Product Change Notification

Date Issued :	November 11, 2022	PCN Number :	512997
Reason for Change :	Change Supplier		
Description of Change :	Supplier Change : this notification is to inform you about a change of resin suppliers impacting the part(s) attached as per list. No changes will be made to product as part of this change.		
Reason for Short Notice :	Special Request		
Assessment of Change :	Reliability Test Report/s		
Planned Implementation Date :	February 01, 2023		
Sample Availability Date:	November 09, 2022		
Internal Molex Qualification Date :	November 09, 2022		
Last date to request Samples by Customer :	January 18, 2023		
Traceability Code Markings / Date :	Lot information on label

Change Overview

Change Overview

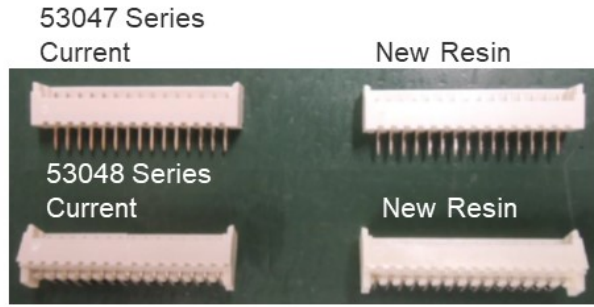
➤ Color difference

After changing the resin, the color will be slightly brighter.

➤ Identification: During the first 6 months of production with an alternative material, add an "M" to the end of the traceability number on the label (see photo) to identify products made with the alternative material.
